Carlyle/Eisenhower East Design Review Board (DRB) Application

PROJECT NAME: Carlyle Block P BLOCK: P

DESCRIBE THE REQUEST BRIEFLY: Approval to minor modifications to the previously approved design of the South Tower of Carlyle Block P.

765 JOHN CARLYLE - SOUTH TOWER

5 TOP OF BUILDING MATERIAL CHANGES

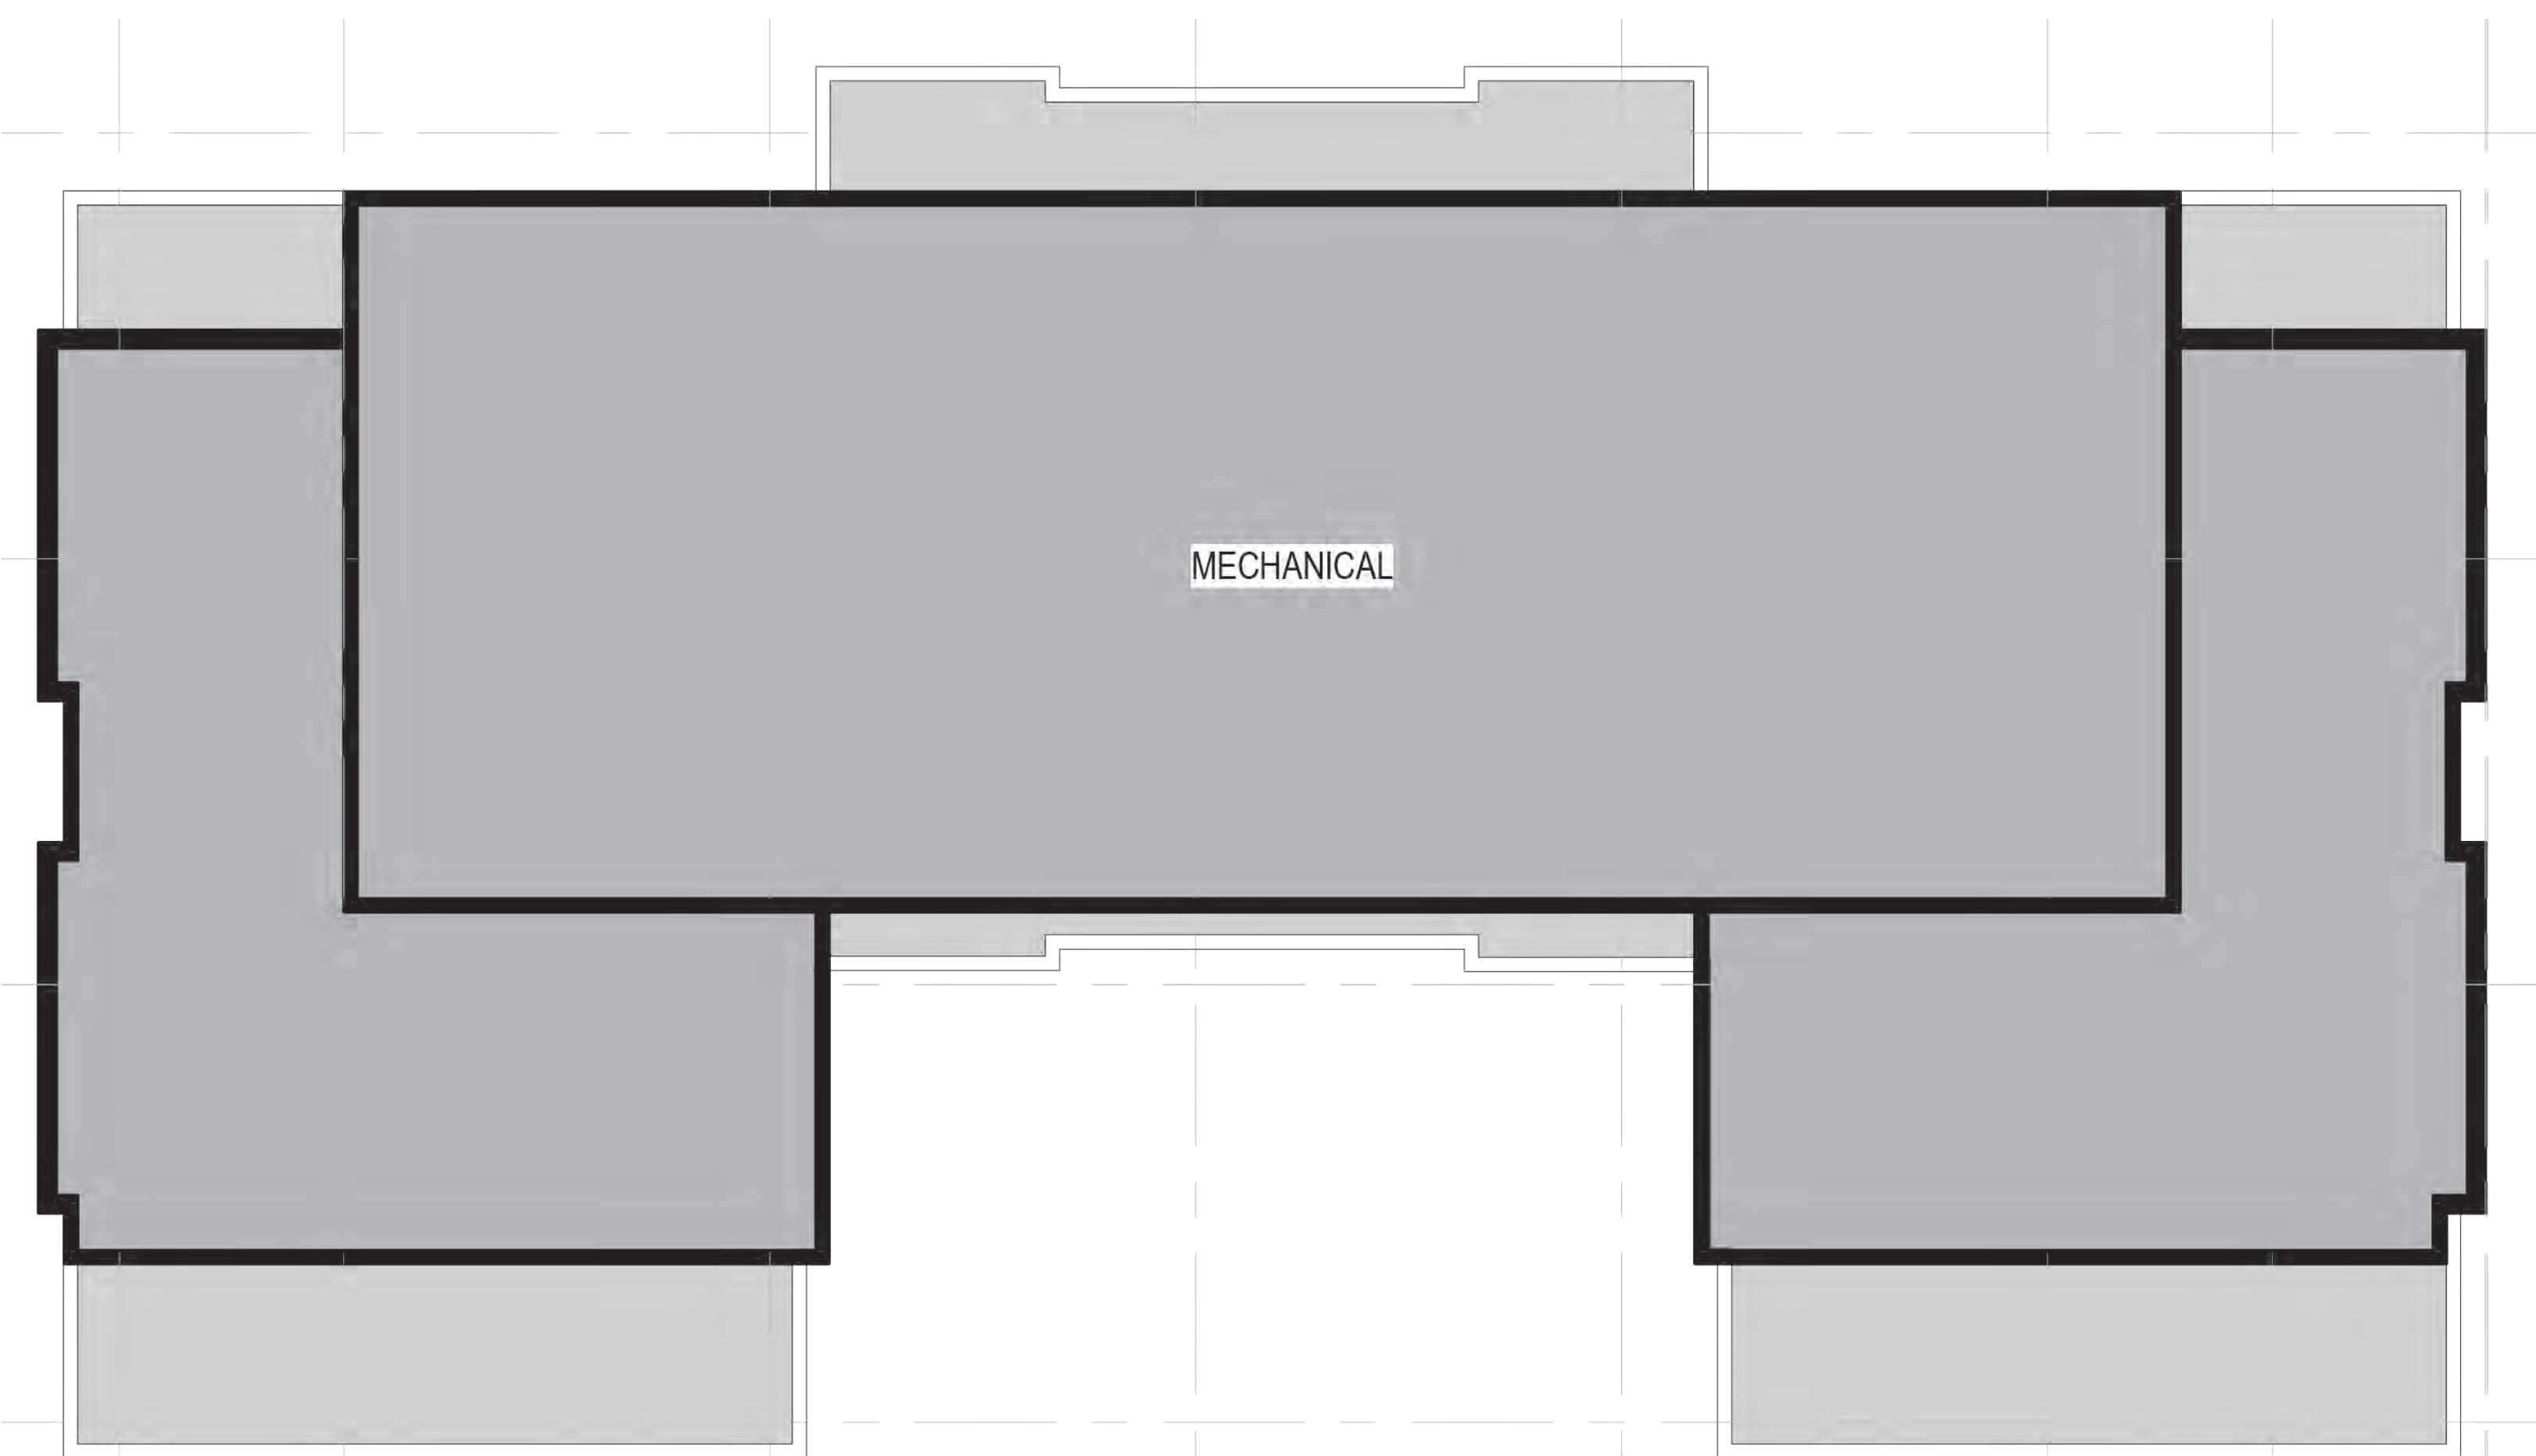
CHANGED FROM METAL TO FIBER CEMENT PANEL WITH COLOR TO MATCH LIGHT BRICK AND ELIMINATED OPENINGS

6 TOP OF BUILDING: ENCLOSURE AND HEIGHT CHANGE

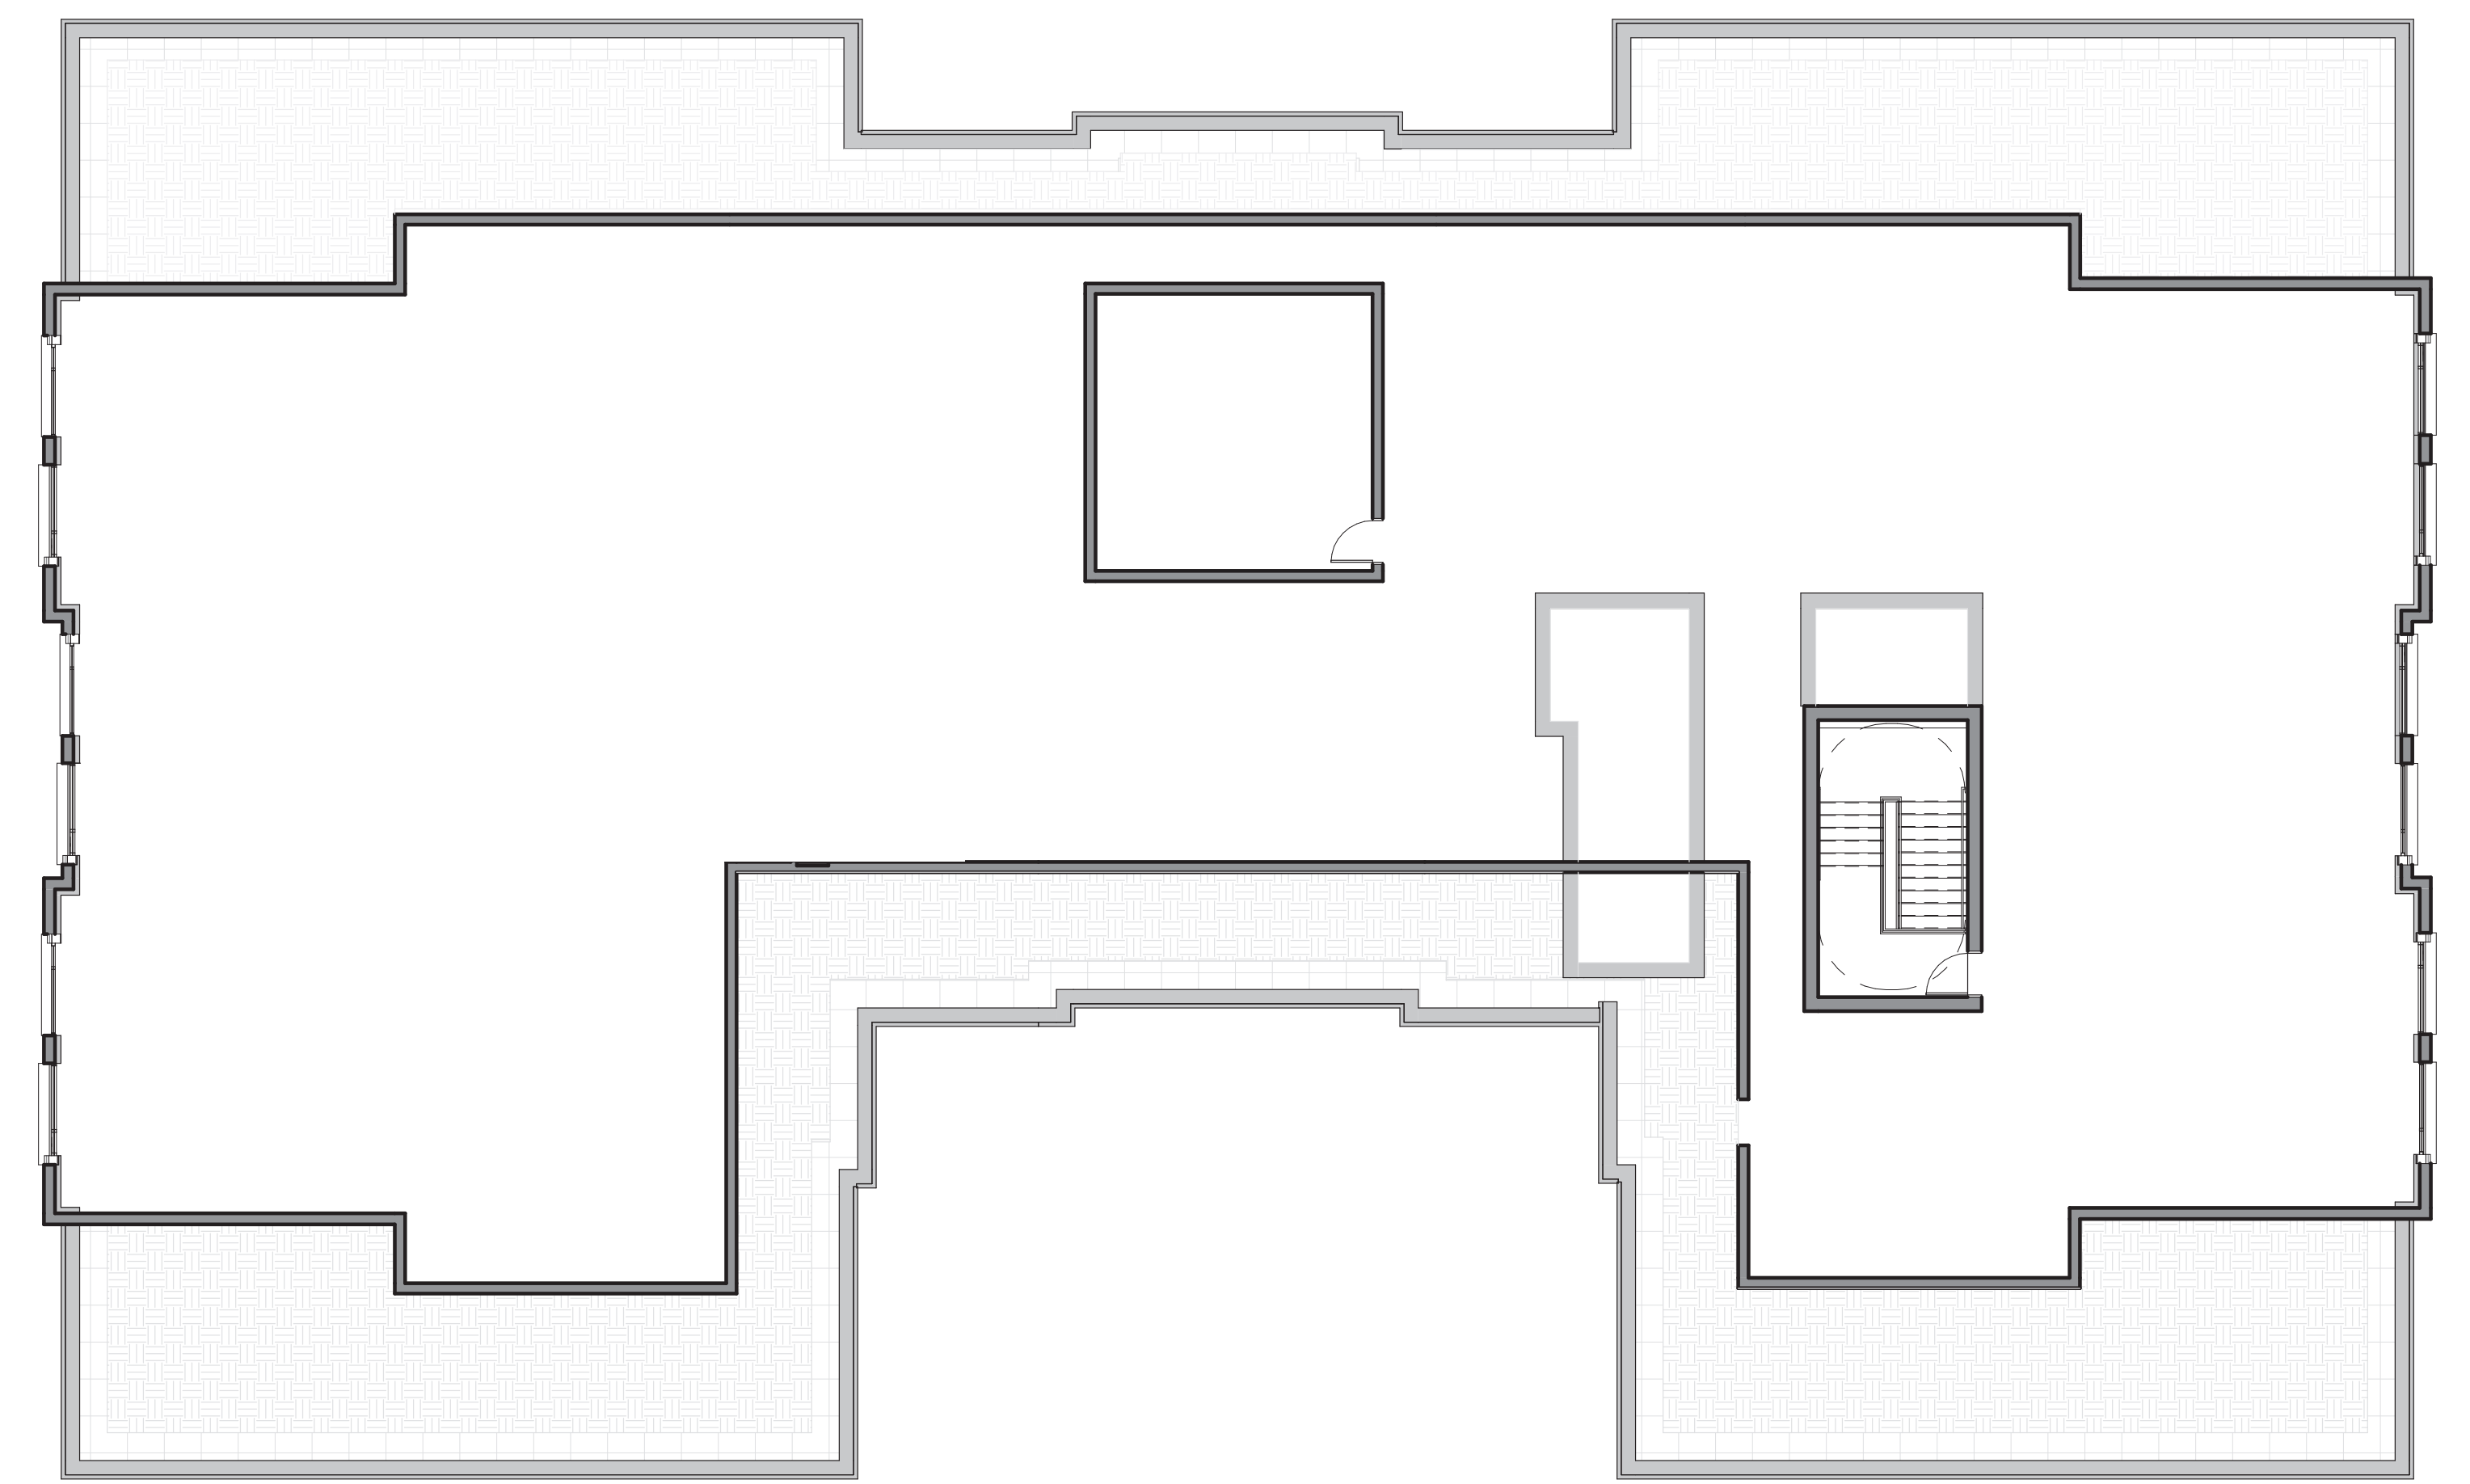
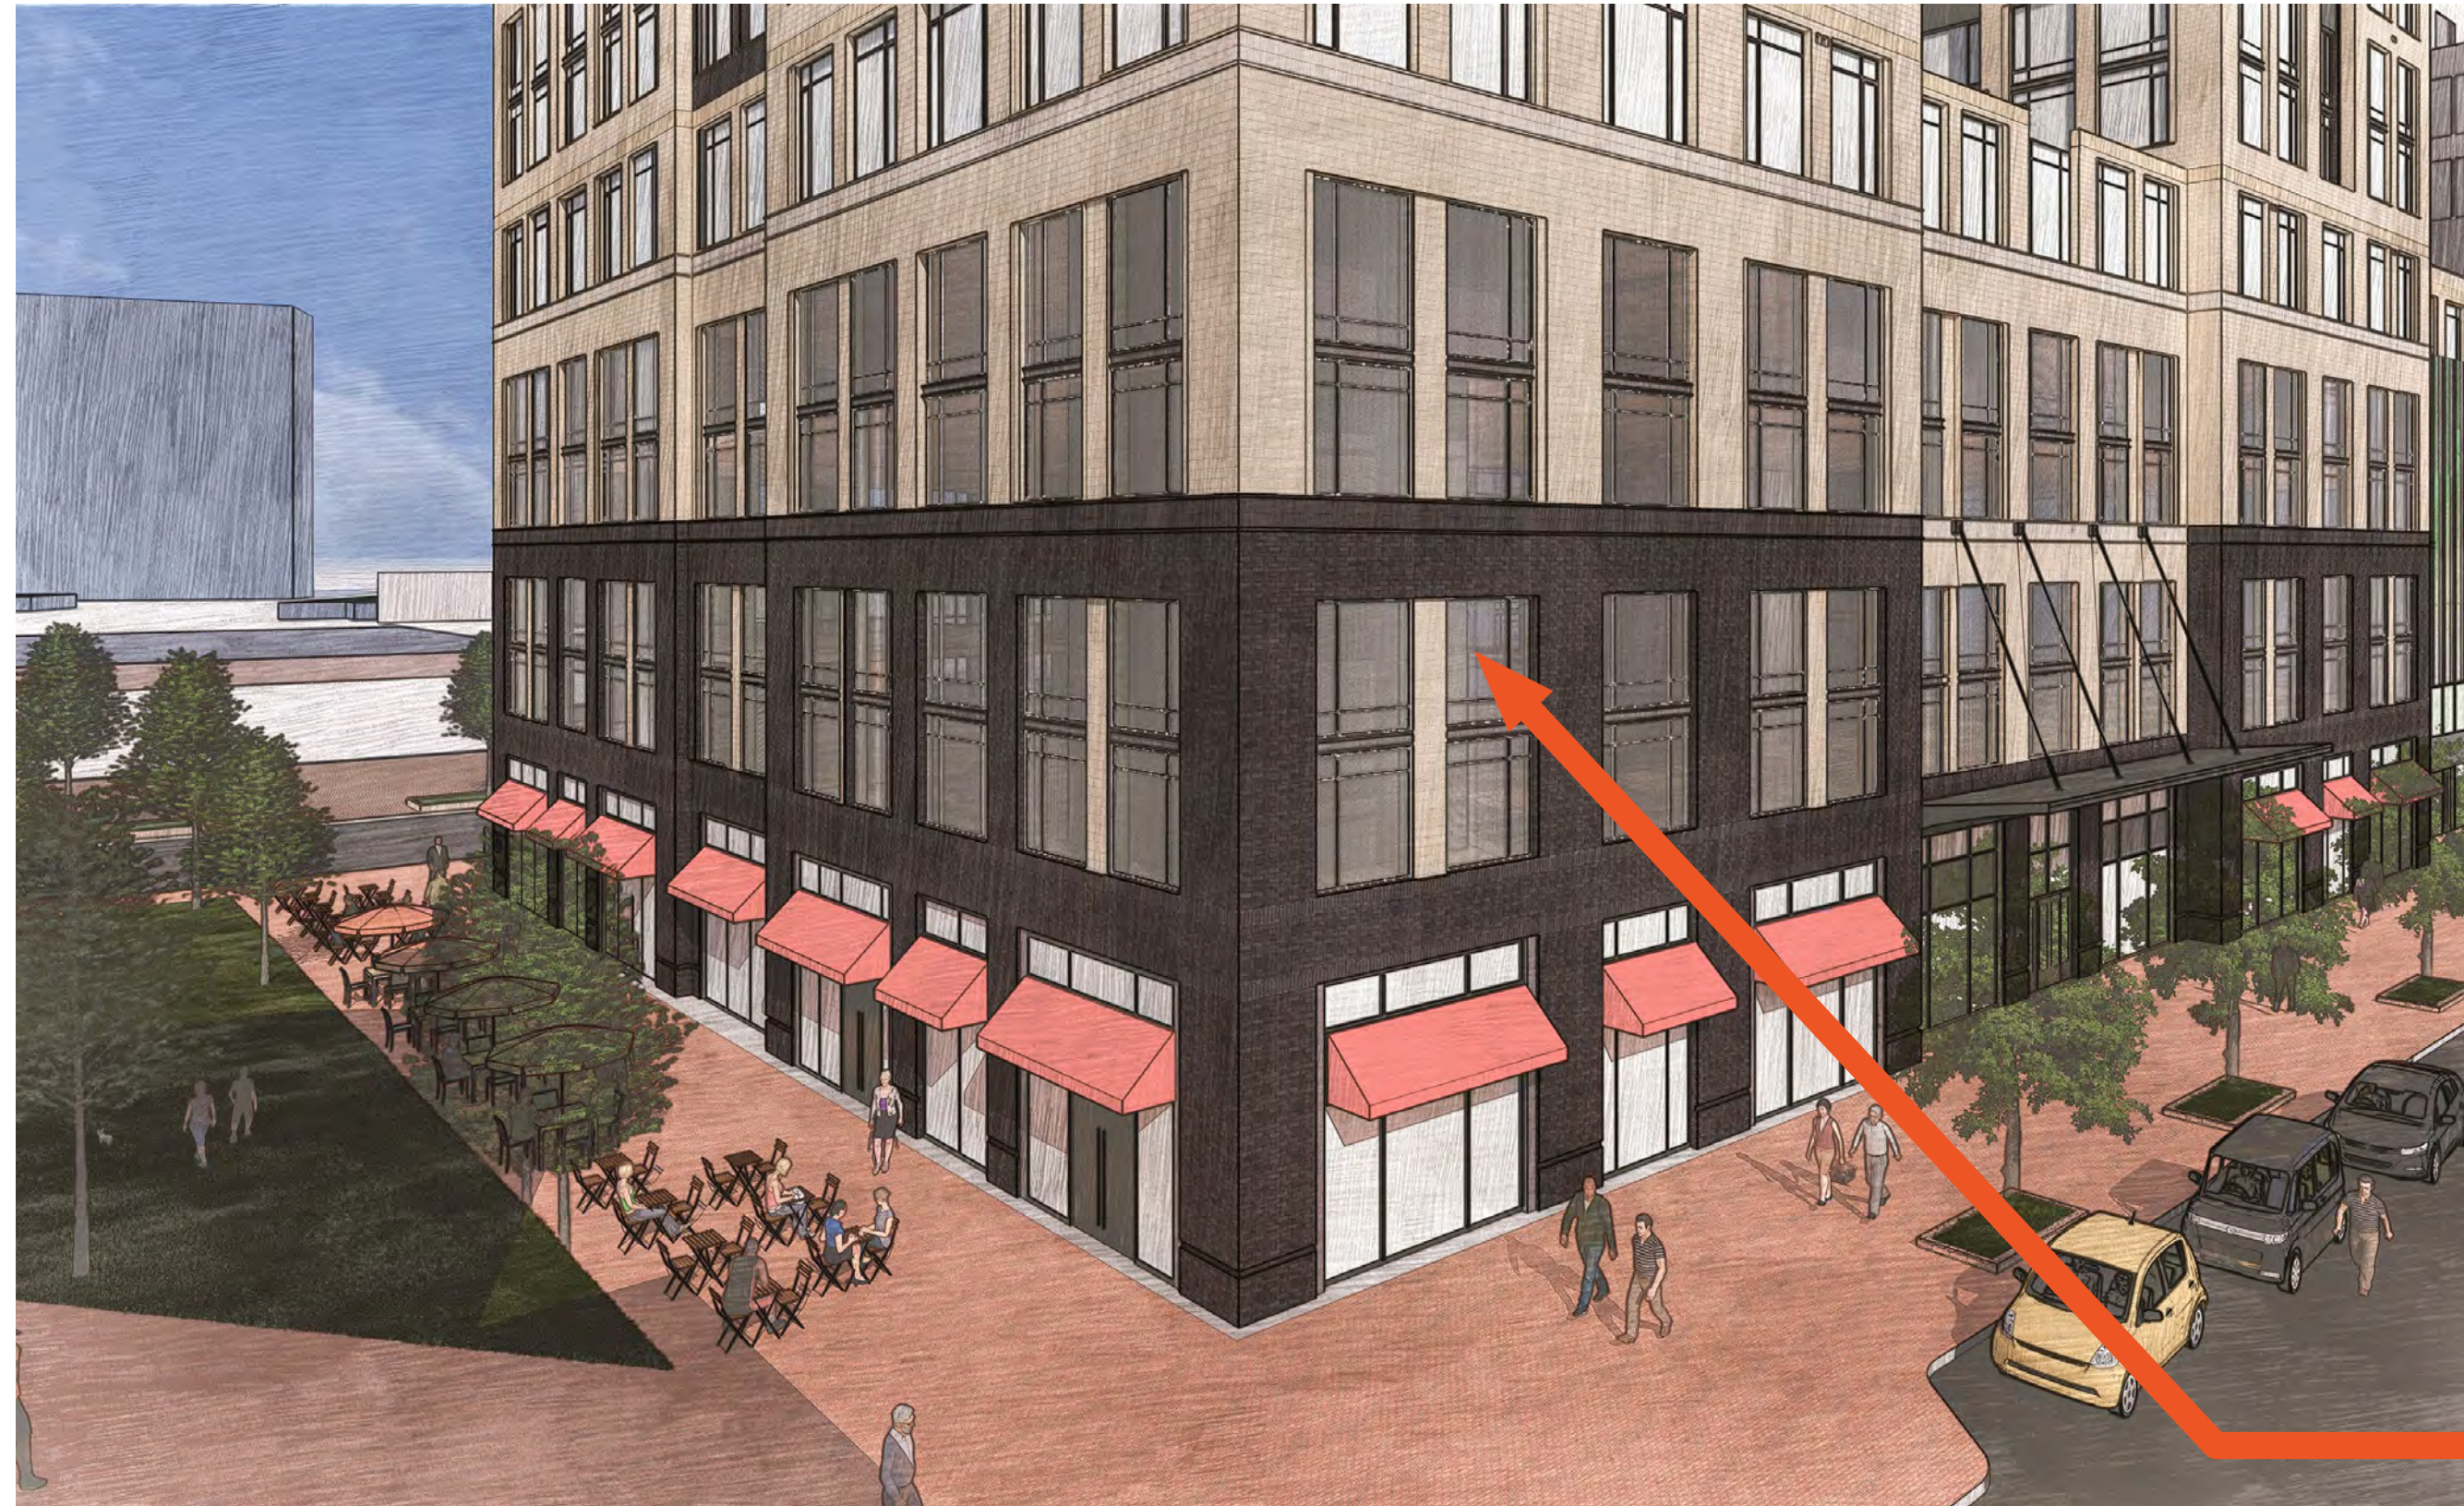
- Revised the layout to accomodate defined equipment
- Changed screen wall height from 17' to 15'
